NEDO-21052-A  
75NED53  
CLASS I  
MAY 1979

# MAXIMUM DISCHARGE RATE OF LIQUID-VAPOR MIXTURES FROM VESSELS

This approved version of report NEDO-21052 (September 1975) is being provided in accordance with the NRC's topical report program. This report NEDO-21052-A consists of the original text of NEDO-21052, the NRC staff letter accepting this report as a reference, the NRC staff Topical Report Evaluation and the supplementary information General Electric provided to the NRC staff during the review of NEDO-21052.

SUBJECT: REVIEW OF GENERAL ELECTRIC TOPICAL REPORT NEDO-21052,  
 "MAXIMUM DISCHARGE RATE OF LIQUID-VAPOR MIXTURES FROM  
 VESSELS"

Fig.1 Critical mass flux - homogeneous, equilibrium steam-water

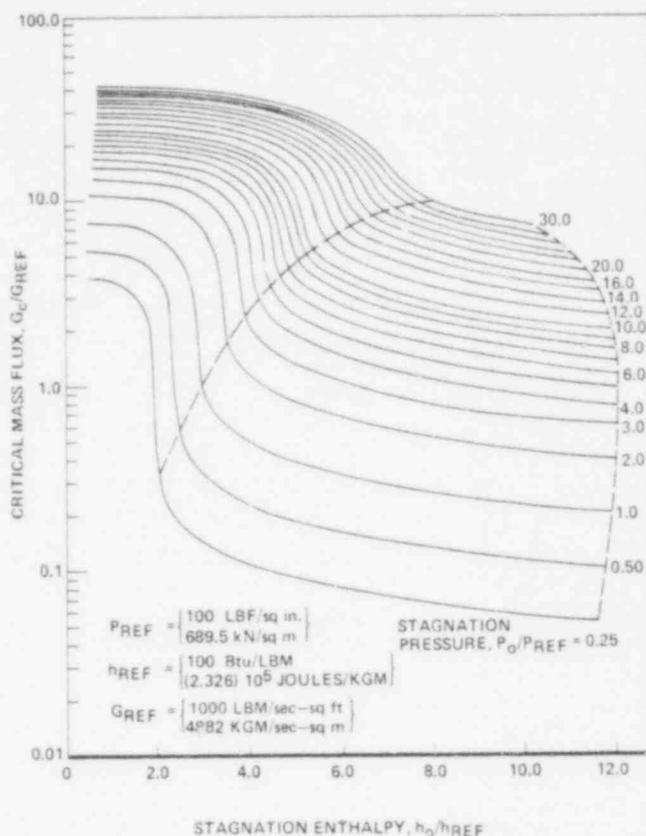
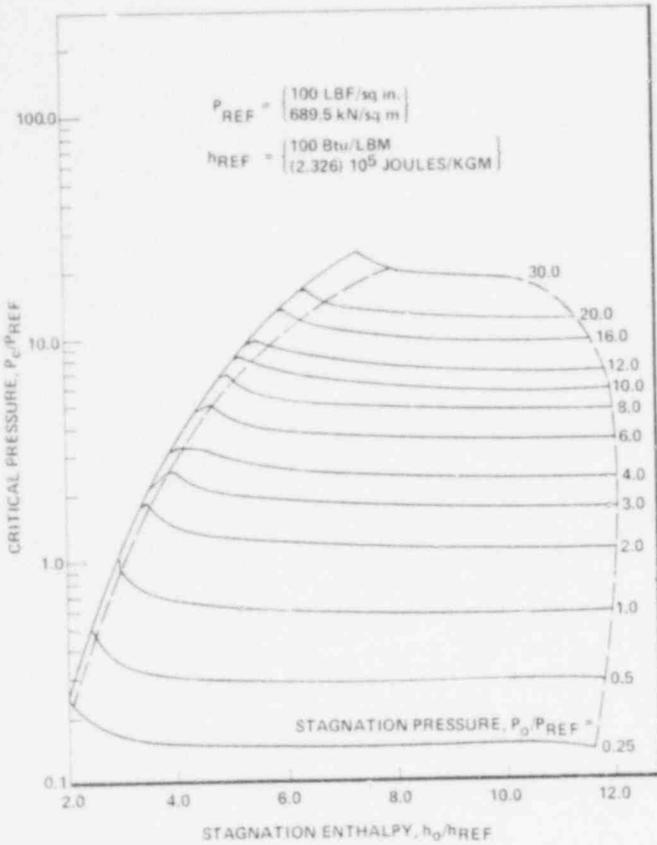
Provide the details of the mathematical solution of equation 8 used to produce the critical flows in Figure 1 and the critical pressure ratios in Figure 2.

One could obtain the partial derivative of  $v$  with respect to  $P$  at constant entropy  $s$  directly from a programmed steam table library at given values of  $P$  and quality  $x$ , then obtain corresponding stagnation enthalpy  $h_o$  and pressure  $P_o$  from additional energy and state equations. However, the procedure employed to obtain Figure 1 of Ref. 1 was based on the energy equation,

Fig.5 Blowdown rate of saturated water

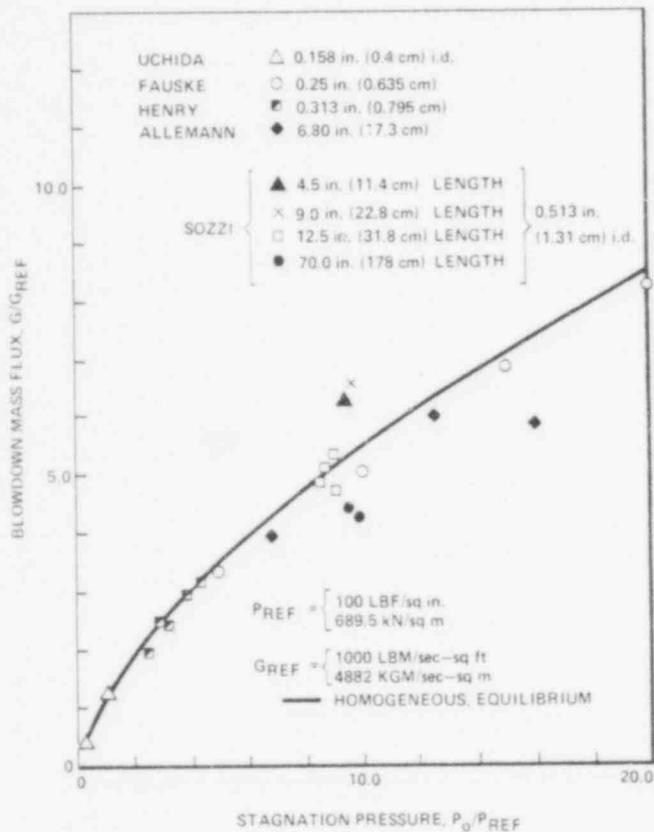
Page 2 of NEDO-21052 states that for pipe lengths greater than 10 cm, the discharge rate is unaffected by further increases in pipe length. This conclusion is inconsistent with the data of Sozzi\* in Figure 5 which indicate the flow is greater for a 9-inch pipe length than for a 4.5-inch length or a 12.5-inch length. Discuss the reasons for this inconsistency.

The word "unaffected" in NEDO-21052 is too strong, and would be accurate if it were revised to read "not strongly affected". Further increases of pipe length beyond approximately 10 cm show an extremely reduced effect on flow rate. The data of Sozzi and Sutherland shown in Figure 5 of NEDO-21052 is subject to a degree of uncertainty in measurement, and some scatter is expected. The collection of data presented in Figure 5 of NEDO-21052 from several investigators shows a strong trend of agreement with the HEM.

Fig.8 Critical flow properties at pipe exit

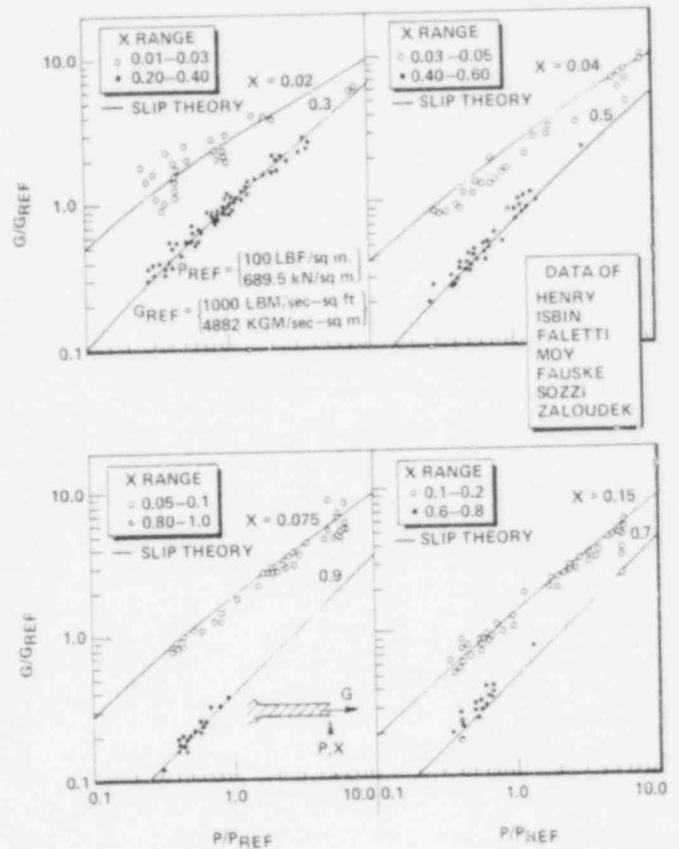
- (b) Faletti's data was obtained in annular flow passages which were long enough to assure phase equilibrium. Figure 8 of NEDO-21052 shows that this data is well predicted by the SEM in terms of exit choked properties. However, upstream stagnation properties were not presented and a meaningful comparison with the HEM cannot be made (Summary Points 1 & 2 of Section I).

- (c) A meaningful comparison cannot be made with data of Zaloudek for short flow passages of 3.0 inches and less (Points 1 & 2 of Section I). However, Zaloudek's data for longer flow passages is well predicted by the SEM in Figure 8 of NEDO-21052.

FIGURE A-A

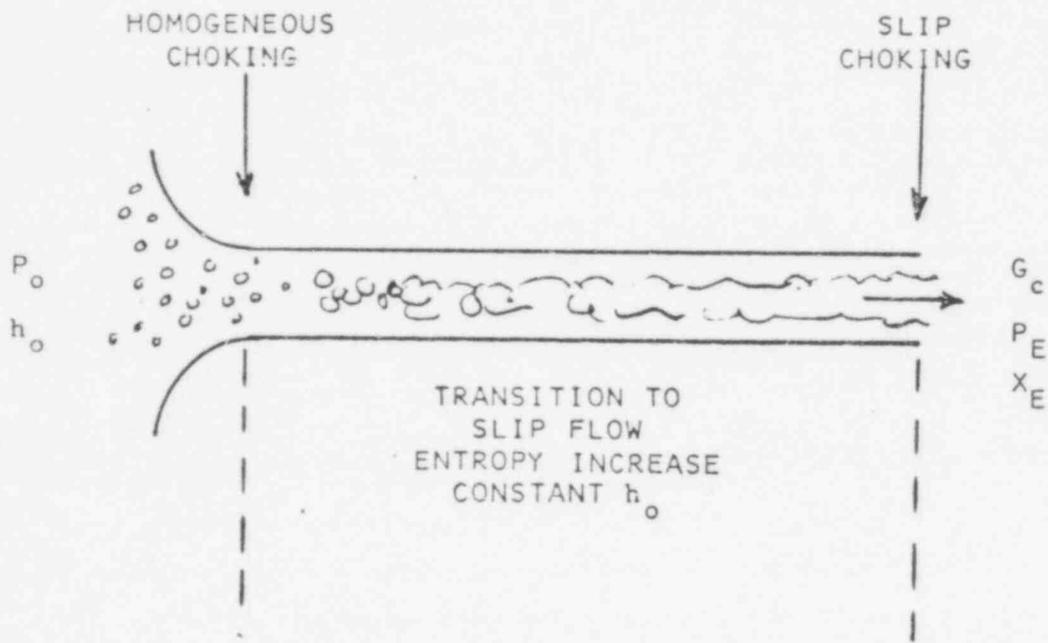
Point 3. Two choked flow conditions can occur in a blowdown flow passage. One choked condition occurs near the entrance, and another choked condition at the exit. See Figure AA.
